WATERBURY SANITARY FORCE MAIN

EL PASO COUNTY, CO

UTILITY CONSTRUCTION SET

APRIL 2026

UTILITY CONSTRUCTION SET
EROSION CONTROL PLAN - INITIAL/INTERIM

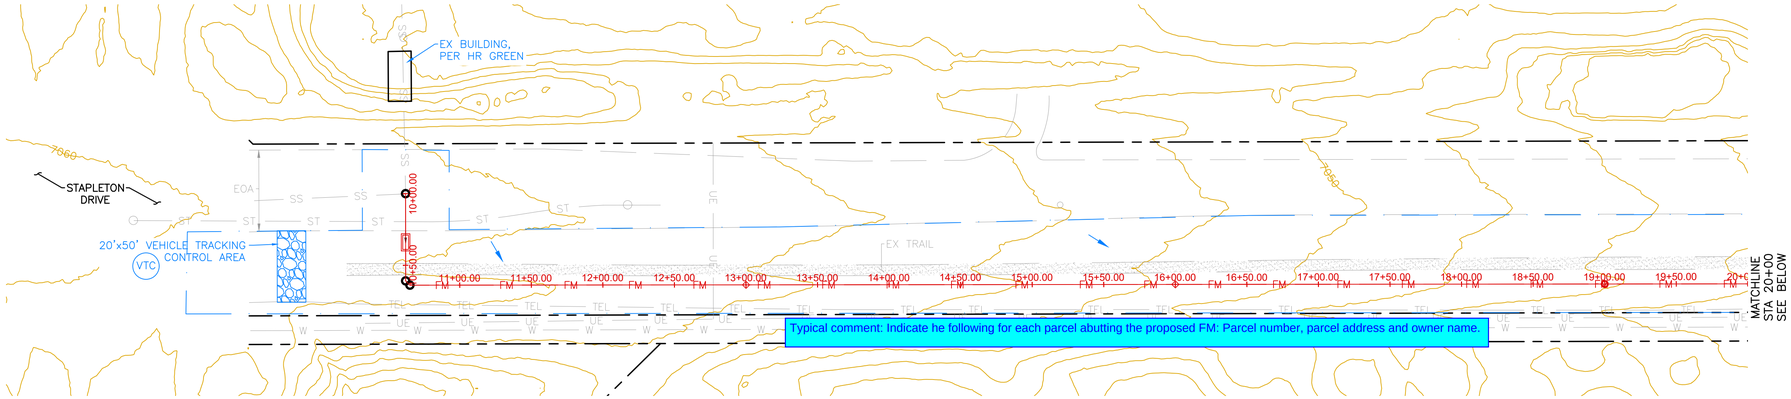
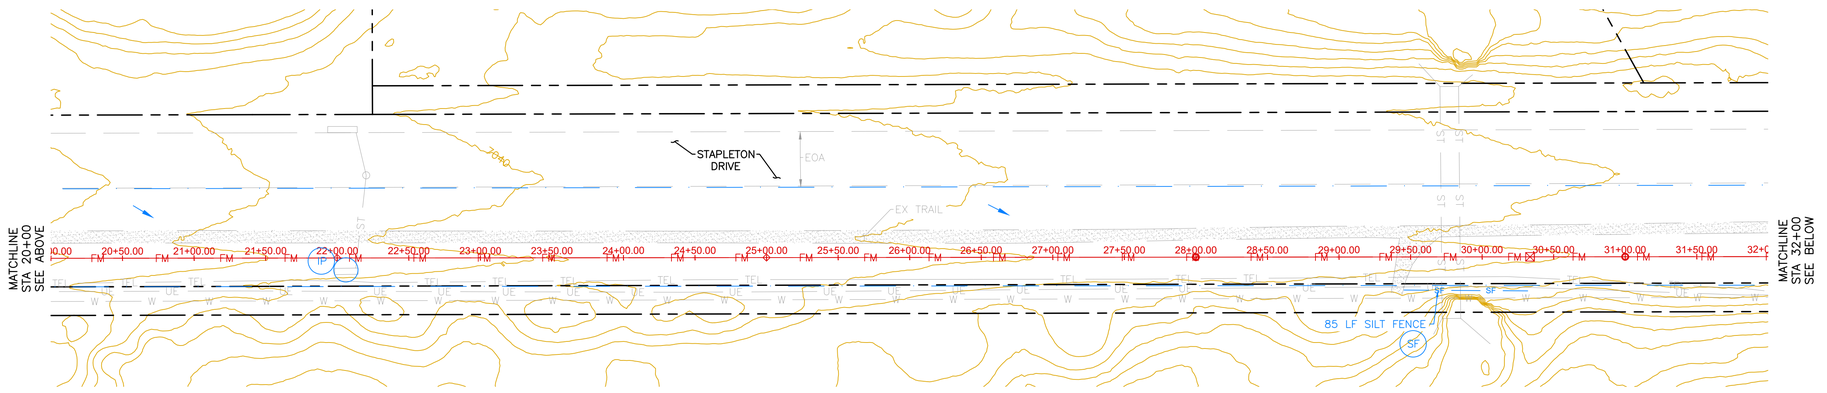
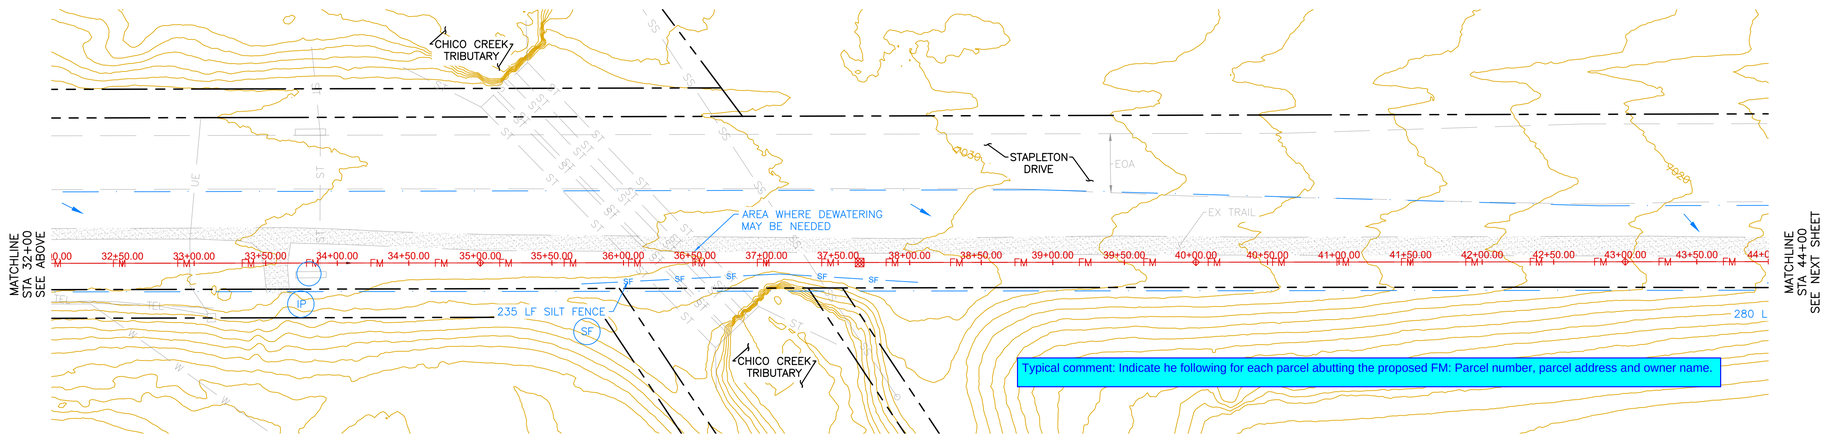
Add the following note "the open cut shall not exceed 250 LF per day, the developer can not open ground if he/she can not back fill it at the end of the same day and make it safe to the public (No open cut to remain open after working hours).".

Typical comment: Indicate he following for each parcel abutting the proposed FM: Parcel number, parcel address and owner name.

Typical comment: Indicate he following for each parcel abutting the proposed FM: Parcel number, parcel address and owner name.

UTILITY CONSTRUCTION SET
EROSION CONTROL PLAN – INITIAL/INTERIM

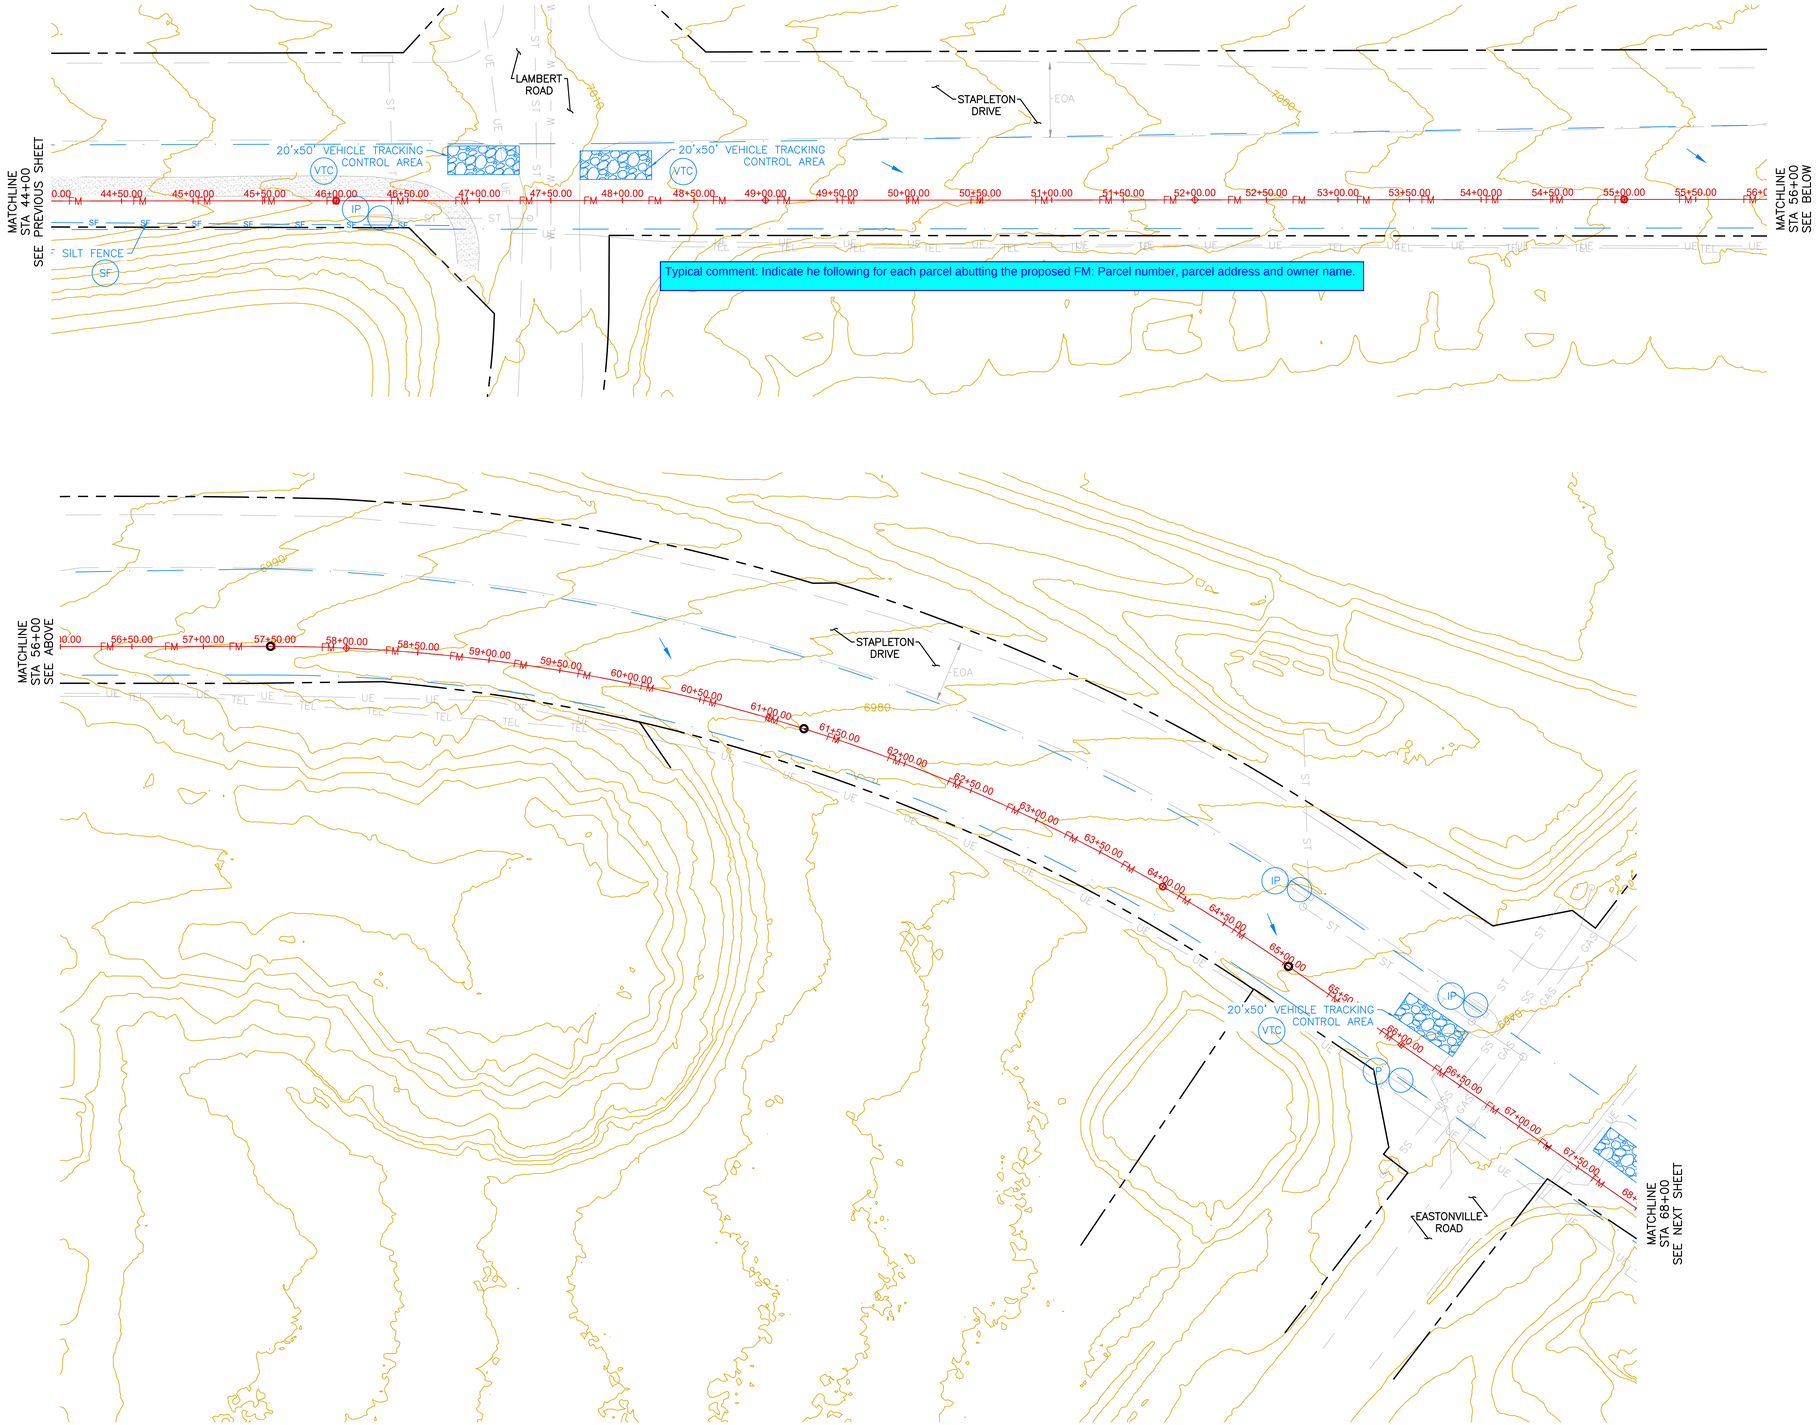
Typical comment: Indicate he following for each parcel abutting the proposed FM: Parcel number, parcel address and owner name.
